THM 440-T4 NEW 1-2 CLUTCH HOUSING AND PISTON

CHANGE: There has been a new model 4T60 (440-T4) introduced for the 1991 "W" car, IWWH, that has

Figure 1

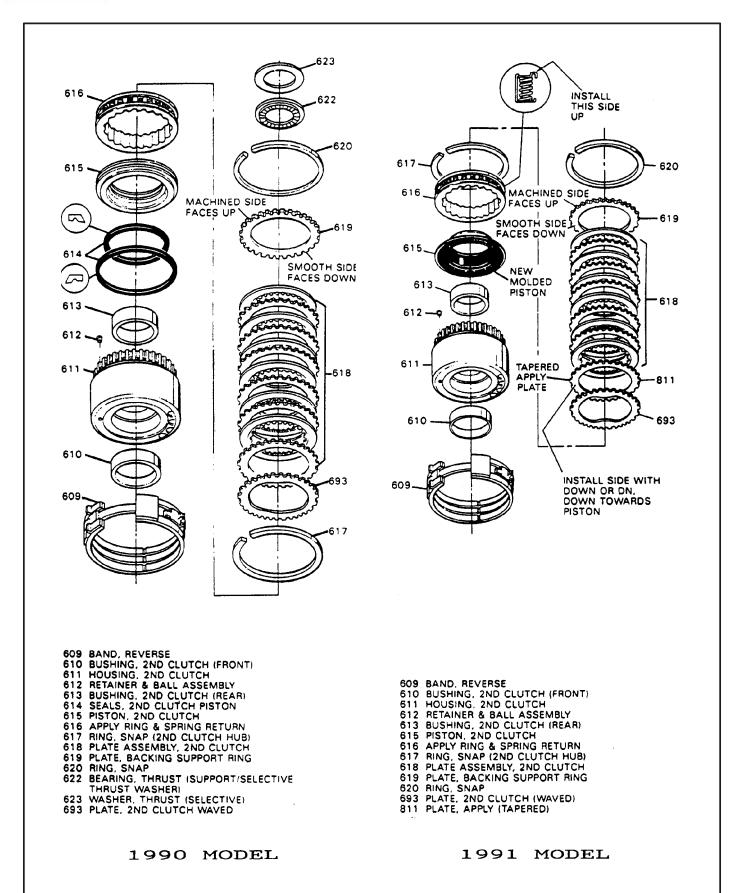
- (1) 2ND CLUTCH HOUSING Snap ring grooves moved and revised clutch stack up, along with dimensional changes on the center journal area so as to accommodate the new moulded piston and seal assembly (See Figure 1).
- (2) 2ND CLUTCH PISTON Now has moulded seal assembly on the piston (See Figure 1).
- (3) APPLY RING AND RETURN SPRING ASSEMBLY Revised dimensions to accommodate the new moulded piston assembly, and the revised clutch stack-up. (See Figure 1)..
- (4) REVISED CLUTCH STACK Includes a new "Apply" plate in the stack-up and one less "Koline" steel plate (See Figures 1 and 3).
